# **Response to Requests for Additional Information for the Review of the ARCADIA<sup>®</sup> Reactor Analysis System for PWRs Methodology Description and Benchmarking Results Topical Report**

ANP-10297Q1NP  
Revision 0

AREVA NP Inc.

The ARCADIA® Topical Report [1-1] was submitted to the US Nuclear Regulatory Commission for review in March 2010. A draft set of Requests for Additional Information (RAI) was released by the NRC in December 2010. This document addresses the AREVA NP Inc. responses to a subset of these RAIs.

**Figure 45-A-1: AO Comparisons**

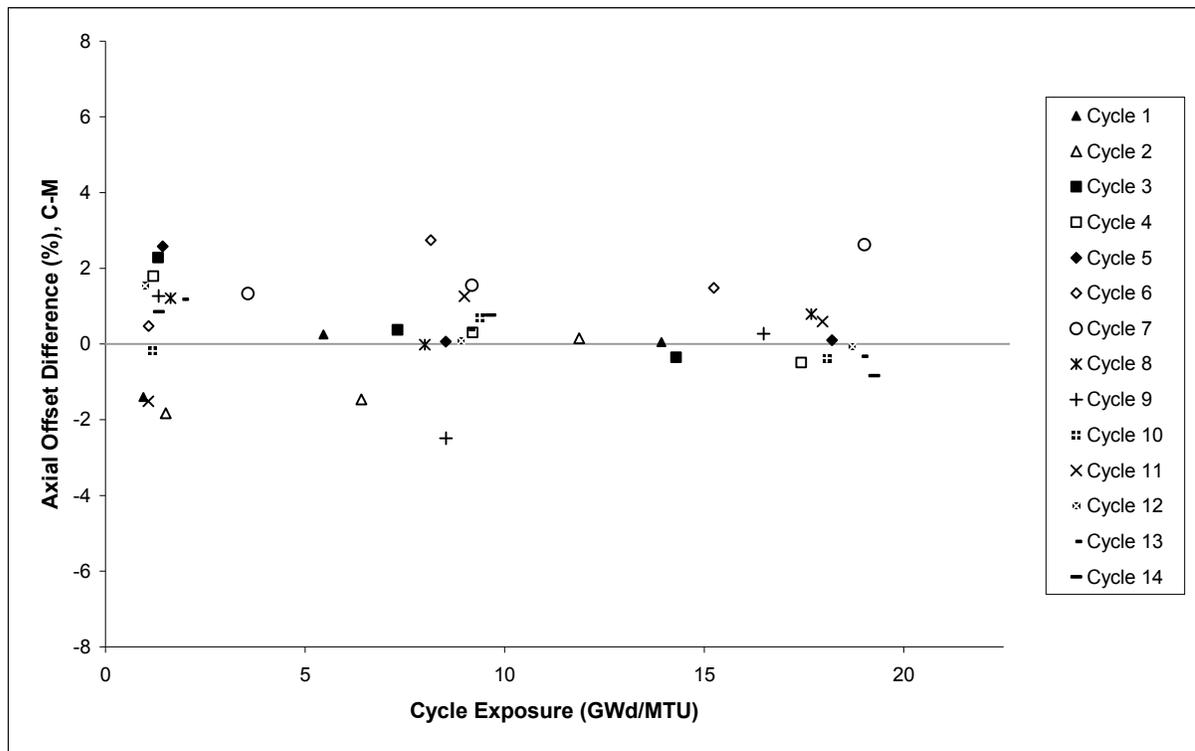
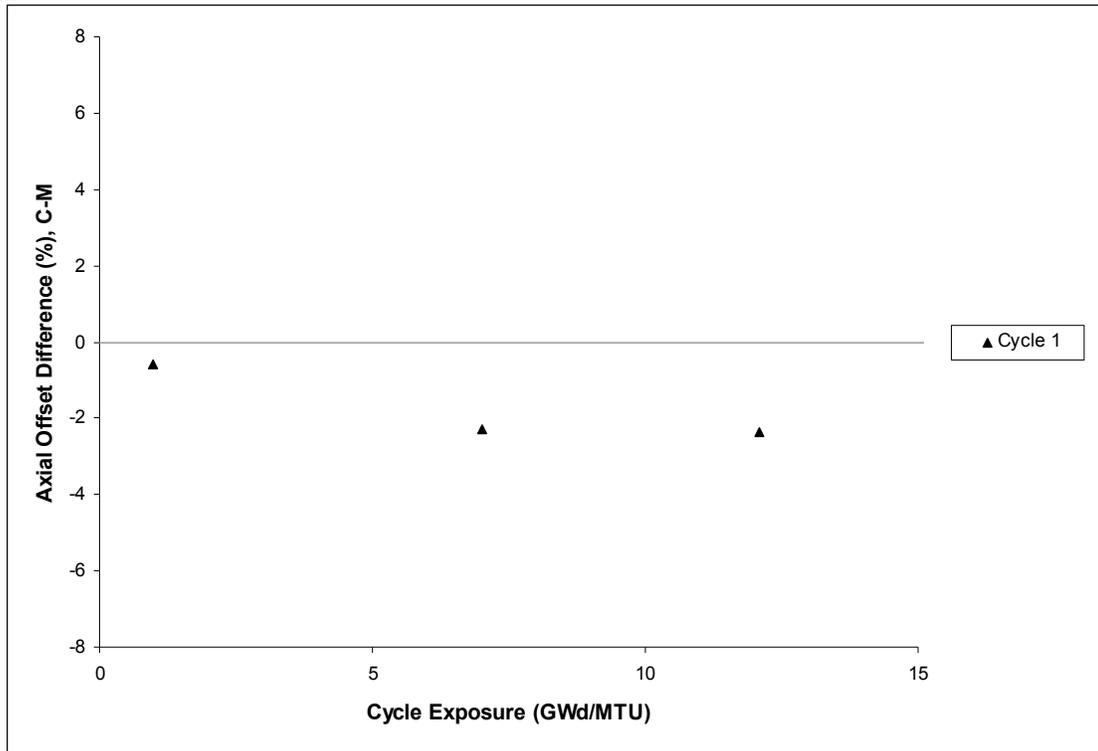
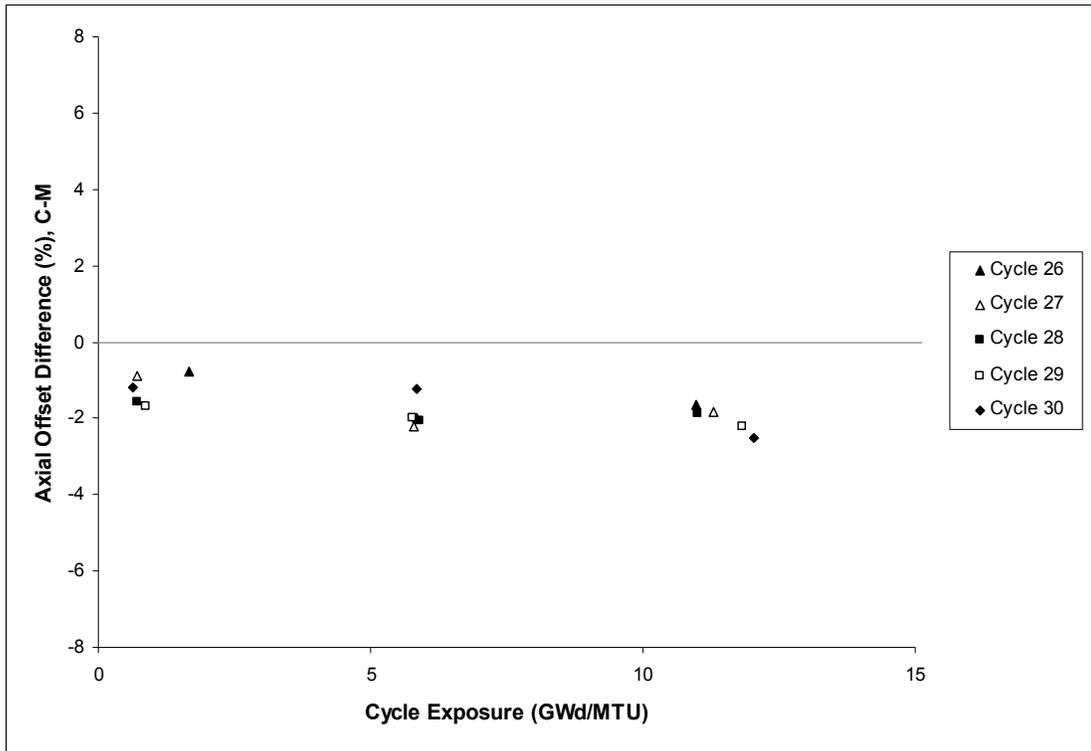
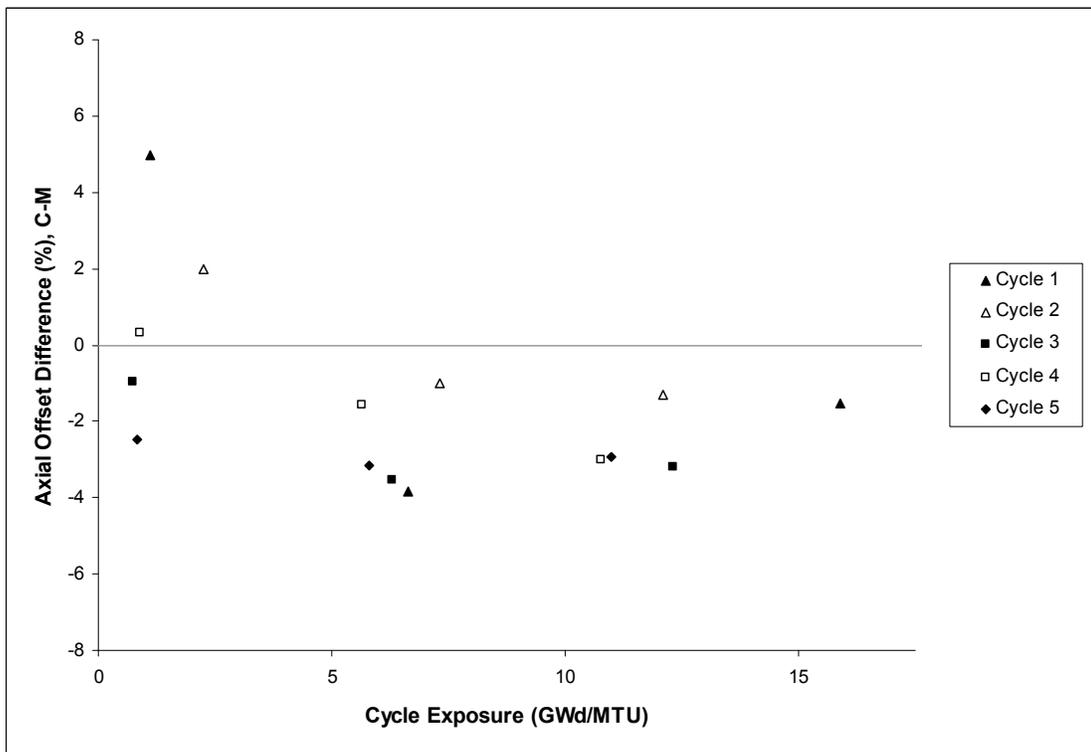
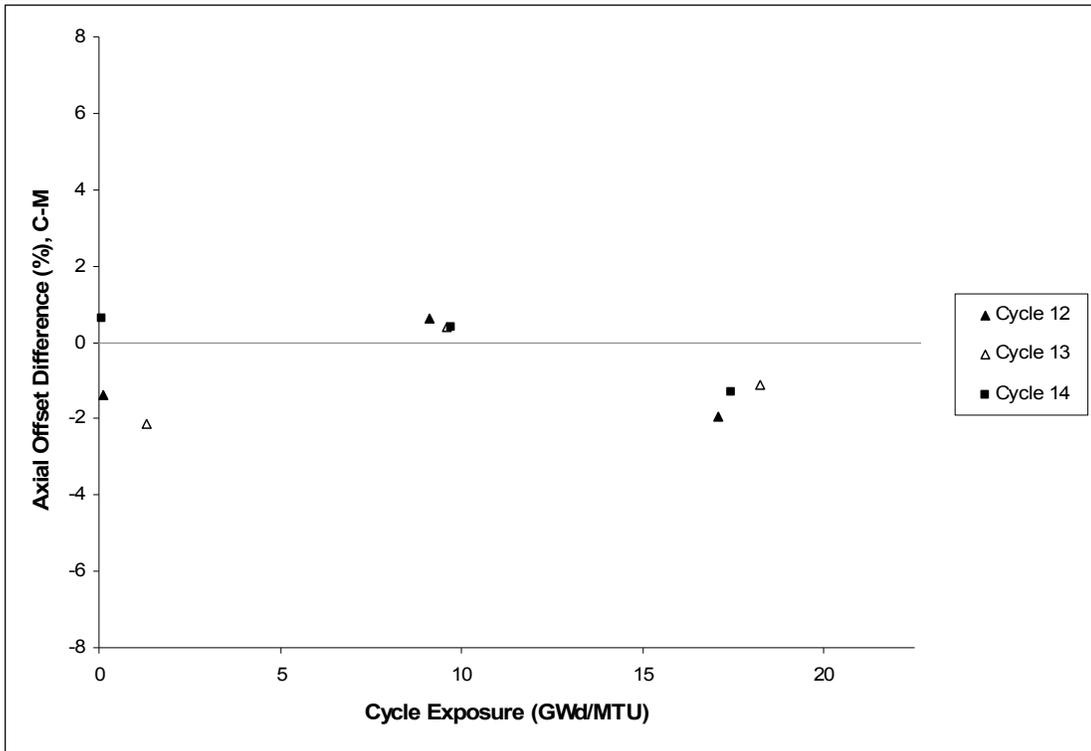
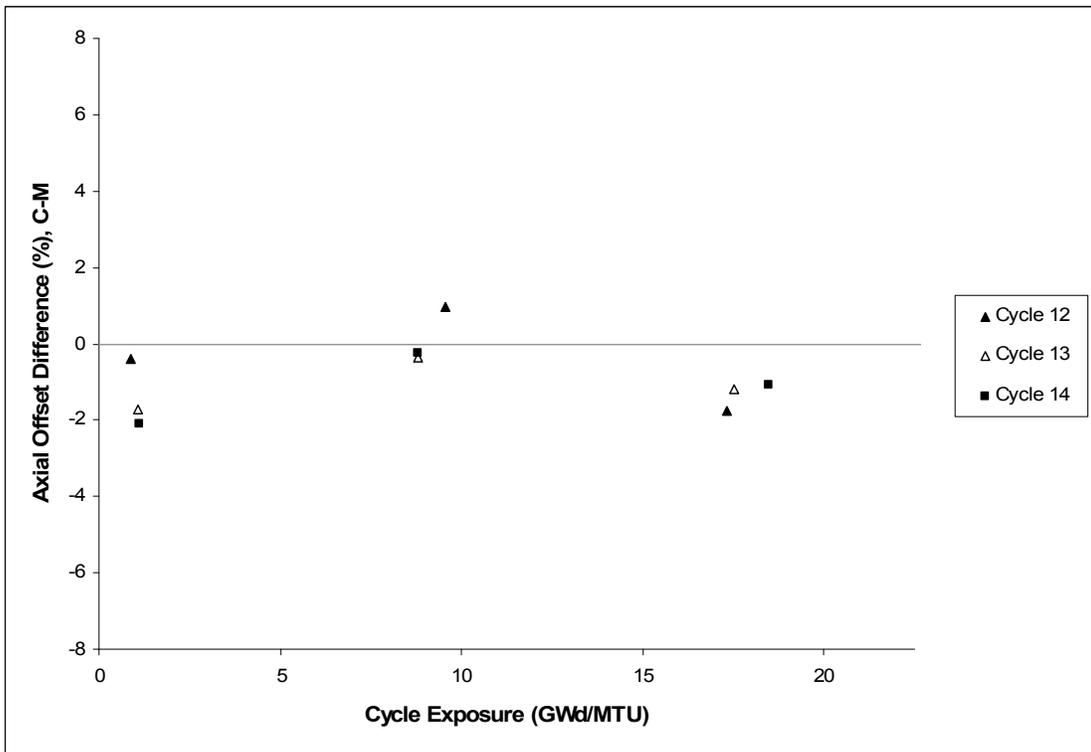
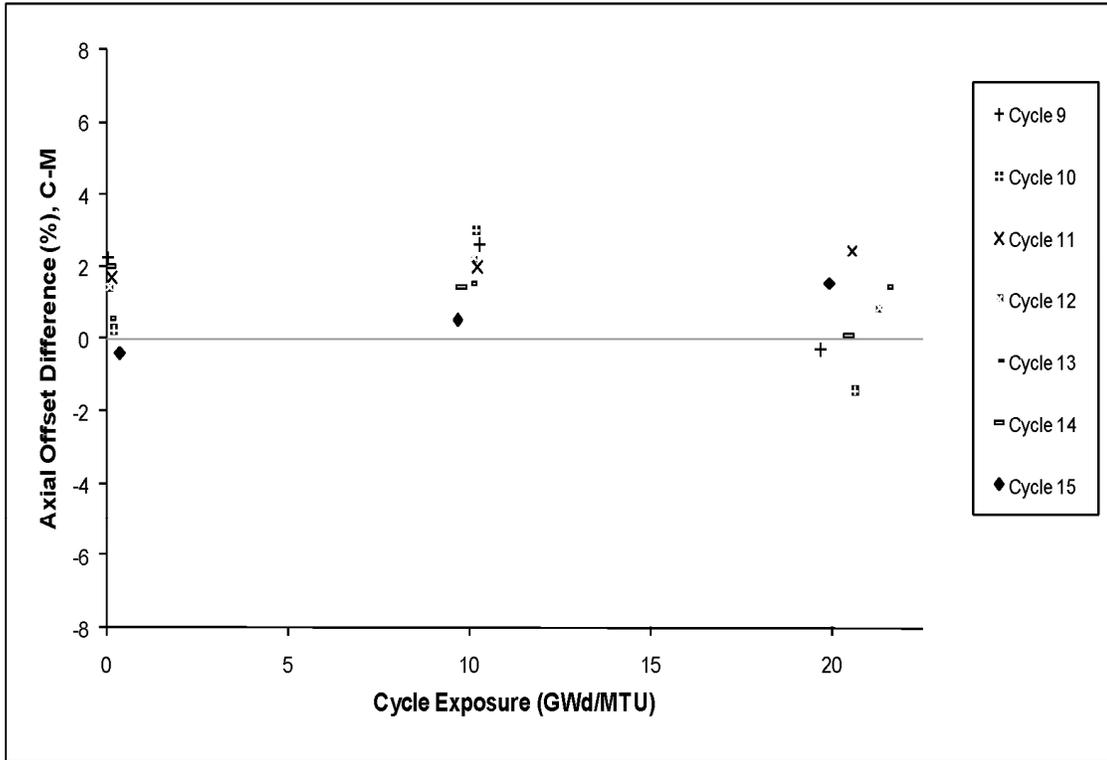
**RAI 45** A summary plot of the difference between calculated and measured axial offset, by cycle, would be beneficial. This may help to discern if the core average axial shape is contributing to the peak assembly power deviations.

Summary plots showing the calculated to measured AO differences at the points in cycle that are consistent with the core average power maps. This was done so that the measured AO values are consistent with the predicted values. The plots of showing the AO differences are given below:
